Cascade Township Planning Commission

RE: Preliminary Plat Review, Section 1, Cascade Township

An application for a preliminary plat consisting of 73.05 acres being subdivided into 22 single family residential lots and 1 out-lot. The property is in the process of being rezoned to R-1, Low Density Residential District. The development is known as Majestic Meadows. The Planning Commission will send their recommendations to the Town Board on the proposed preliminary plat for final approval. Each residential lot as proposed is to be served by an individual septic system and one of four shared wells.

MAJESTIC MEADOWS

PRELIMINARY PLAT

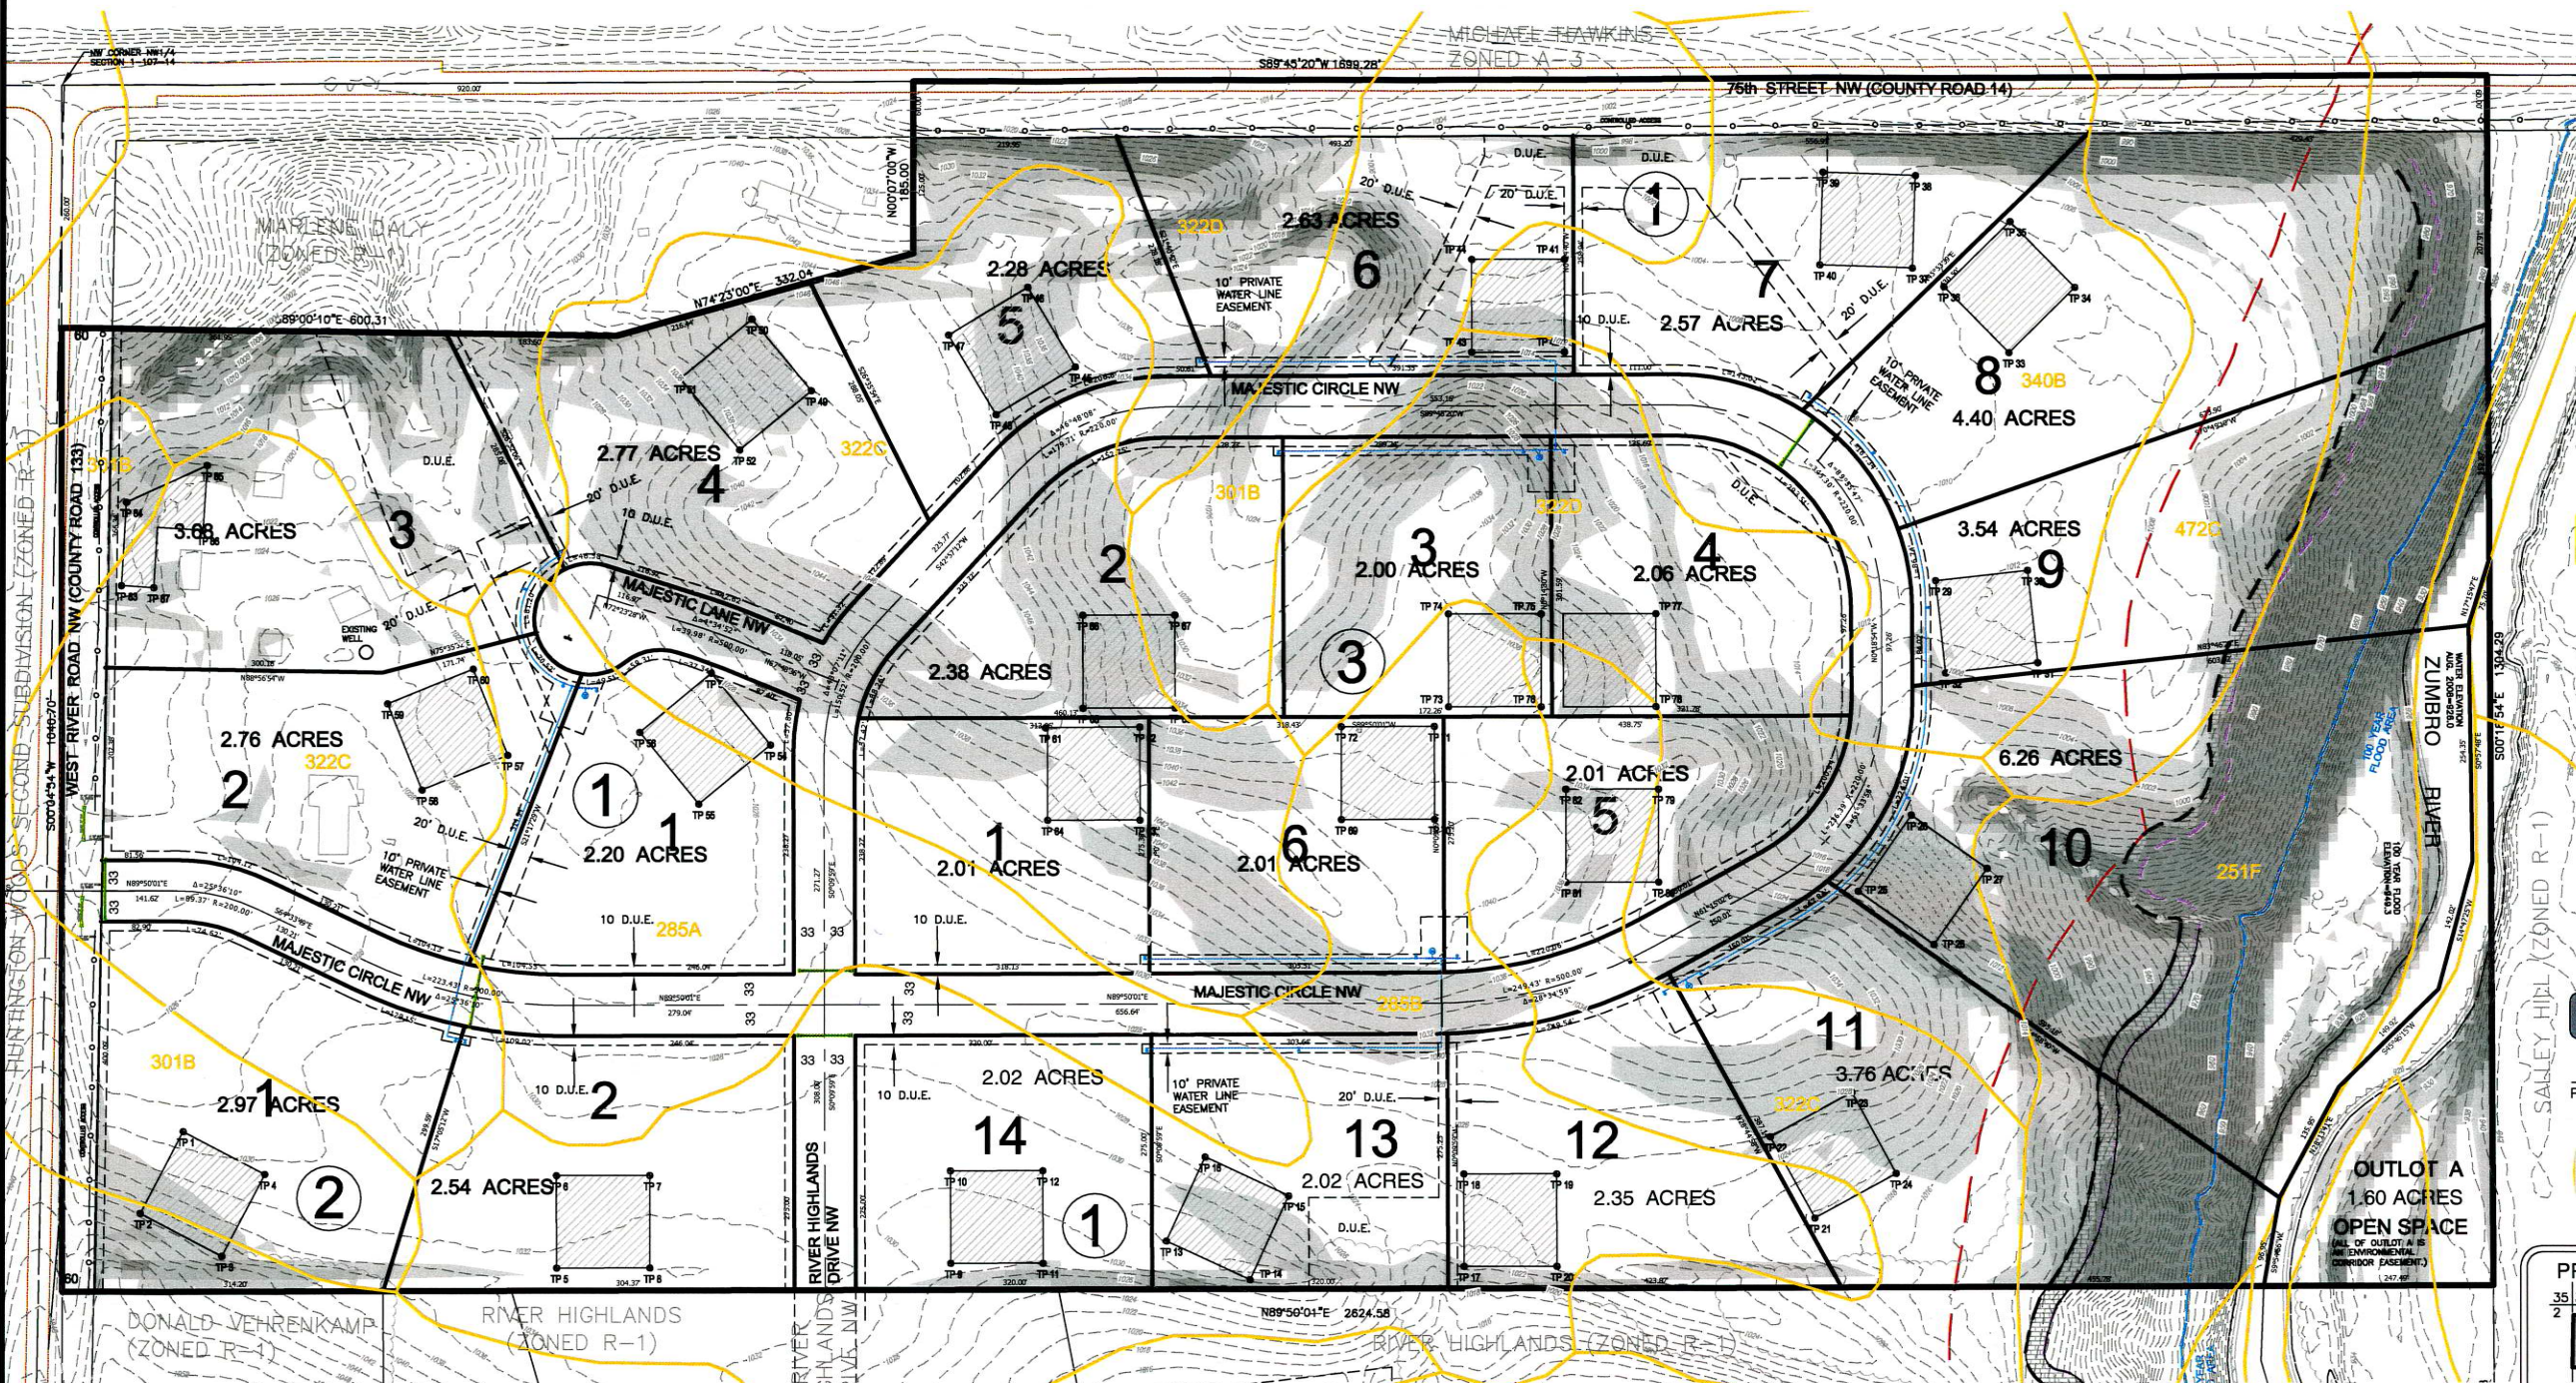
The subdivision name of "Majestic Meadows", along with the roadway name of "West River Road NW (CO. RD. 133)" are present. Additionally the developer is proposing an extension of River Highlands Drive NW from the River Highlands Subdivision and a circular drive with a proposed name of Majestic Circle NW from West River Road NW. Off of the circular drive extends a short cul-de-sac with a proposed name of Majestic Lane NW. These proposed names will need to be approved by Rochester-Olmsted County GIS Division before the recording of the final documents. The plat shows 75th St. NW (County Road 14) which is incorrect. It should be US Highway 63 NW. A new plat with this correction should be required by the Commission.

The property owners and classifications are on the plat, but the zoning classification of Fred Daly's parcel is incorrect. It should be listed as A-3.

The preliminary plat extends approximately 100 feet from the property boundaries. Staff viewed aerial photos of the proposed development and found nothing unusual extending beyond the 100 foot shown on the plat. Structures are shown on the property located at the intersection of US 63 NW and West River Road NW (Daly property), but no other structures outside of the platted area are shown. Additional structures would be shown on the parcel just south of the development along West River Road NW (Vehrenkamp property) if the plat were extended to the 300 feet. As indicated by the developer during the general development phase of approval a (3) variance to allow the structure located on Lot 3, Block 1, to remain has been applied for by the applicant. That variance is scheduled to be considered by the Town Board of Adjustment on August 4, 2014. From the plat

illustration the building seems to infringe upon the drainage easement for a proposed storm-water treatment site. The drainage easement should be moved to make sure the structure is outside of the easement area. Additional information may be desired by the Commission and or the Board as indicated by the above criteria.

The water elevation on the date of the survey and the known high and low water elevations of the river are not provided and may be unknown. The 100 year flood elevation is shown.

Yes, provided on plat. The easements to all of the storm-water treatment areas are twenty feet in width. The engineer should review those easement to make sure the water flows down the easements and that vehicle access to those areas via those easements is possible. Lot 3, Block 1, will need additional consideration since any driveway will require crossing a drainage easement, the developer's engineers should include a driveway design for this lot as part of the grading plan approval for this subdivision.

Drainage and utility easement definitions are not shown.

Outlot A needs to be addressed as to the eventual ownership and regulation there-of. During the approval process of the general development plan, the applicant indicated that an environmental corridor easement similar to the one for Salley Hill and River Highlands would be recorded and cover the entire outlot. Although

this is consistent with the areas on the east side of the river, it leaves ownership of the parcel in question. Provisions should be provided in some type of form during the final platting process in case this does not happen. In addition, a statement of dedication should be shown on the plat for the road right-of-way.

Yes. Four wells are proposed; one serving Lots 1 & 2, Block 2 and Lots 1, 2, 3 & 4, Block 1; one serving Lots 5 & 6, Block 1 and Lots 2, 3 & 4, Block 3; one serving Lots 7, 8, 9, 10, 11 & 12, Block 1, one serving Lots 13 & 14, Block 1 and Lots 1, 5 & 6, Block 3. Four wells, two serving six dwellings and two serving five dwellings.

This plat has storm-water retention sites included as a portion of individual lots and in one case straddling two lots. Storm-water ponds allow a developer to meet the Minnesota Pollution Control Agency's standards for post development storm-water runoff. Many times these ponds are located on outlots and owned by the entire development through a homeowners association. This type of ownership can become an issue if the homeowners association no longer makes payments on the property taxes for the outlots; these outlots can eventually be turned back over to the township for nonpayment of taxes.

The Commission indicated a desire to see some type of easement to allow access to the west side of the river. Nothing on the plat nor any of the supporting documents accomplishes this request.

The applicant has indicated in previous meetings that the dwelling on Lot 2, Block 1, was to remain. The applicant should provide a site plan showing the distances to property lines for the home, septic tank and drainfield. This will allow staff to make sure the setbacks are being met with the new lot lines. This site plan should also include the proposed driveway location which will allow for a new address to be issued for this dwelling once the plat has been recorded.

A well is located on Lot 3, Block 1. If the applicant is proposing to continue to use the well for any of the lots, easements should be shown to allow for such use. If the applicant is proposing to seal the well the applicant should be required to provide copies of the sealing report to TCPA.

County Road 14 (75th Street NW) should be changed to US Highway 63. From the way the plat is drawn, it seems as if this roadway was never dedicated to the public, but a roadway by prescription. As stated earlier, we are still awaiting comments from the Minnesota Department of Transportation. We would assume that the plat should dedicate the sixty foot road right of way to the State of Minnesota, but would recommend whatever MnDot requests as far as title goes.

The roadway design plans and the general development plan have the roadway name from the intersection of River Highlands Drive west listed as Majestic Drive NW. The Preliminary Plat lists the roadway name as Majestic Circle NW. One of the two documents will need to be corrected depending upon which names are approved by the Rochester-Olmsted County GIS Division.

No buffer plan to buffer the lots from the mining activity north of US Highway 63 or the highway traffic on US Highway 63 has been provided. This was discussed during the general development plan and rezoning process but not addressed in the materials submitted with the preliminary plat. Deed restrictions, well agreements, and development agreements are some of the items which will need to be reviewed prior to approval of the final plat.
